OSR SUBDIVISION

APPLICATION	NUMBER H	oldover	DATE _	May 1, 2003
APPLICANT _	OSR Subdivision			
TPRIIOR (REDII	Subdivision

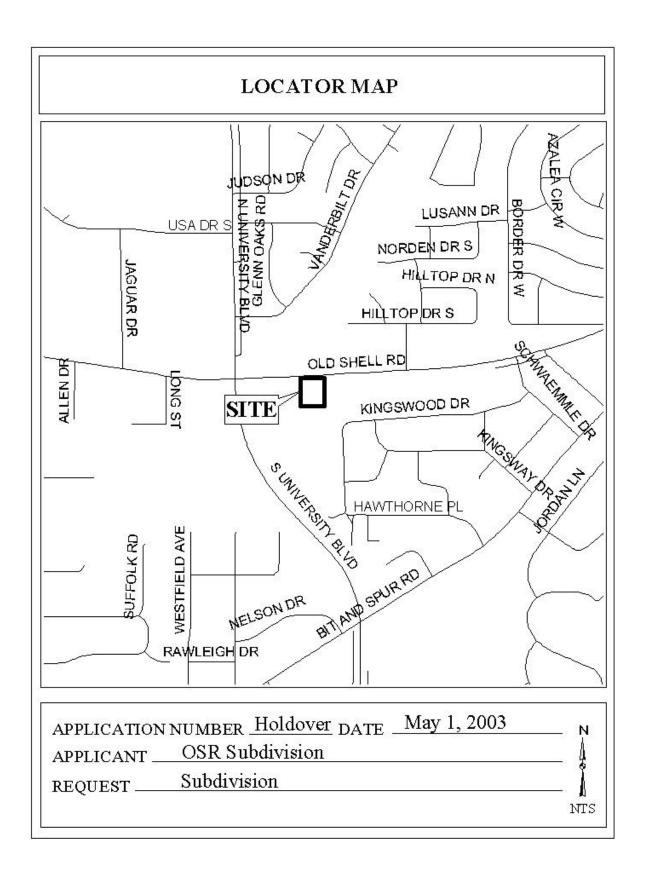
The plat illustrates the proposed three lot, $1.9\pm$ acre subdivision which is located on the South side of Old Shell Road, $500'\pm$ East of university Boulevard. The site is served by public water and sewer.

The site fronts Old Shell Road, a planned major street and as such a 100-foot right-of-way is required. The existing right-of-way is variable; however, the dedication of the necessary right-of-way to provide 50-feet from the centerline of Old Shell Road should be required. Lot 1 is developed and no additional curb cuts should be allowed. As a method of access management, Lots 2 and 3 should be limited to one curb cut each, with the location and design to be approved by Traffic Engineering.

With modifications, the plat will meet the minimum requirements of the Subdivision Regulations and is recommended for Tentative Approval subject to the following conditions: 1) the dedication of the necessary right-of-way to provide 50-feet from the centerline of Old Shell Road; and 2) placement of a note on the final plat stating that Lot 1 is limited to the existing curb cuts, and Lots 2 and 3 are limited to one curb cut each, with the location and design to be approved by Traffic Engineering.
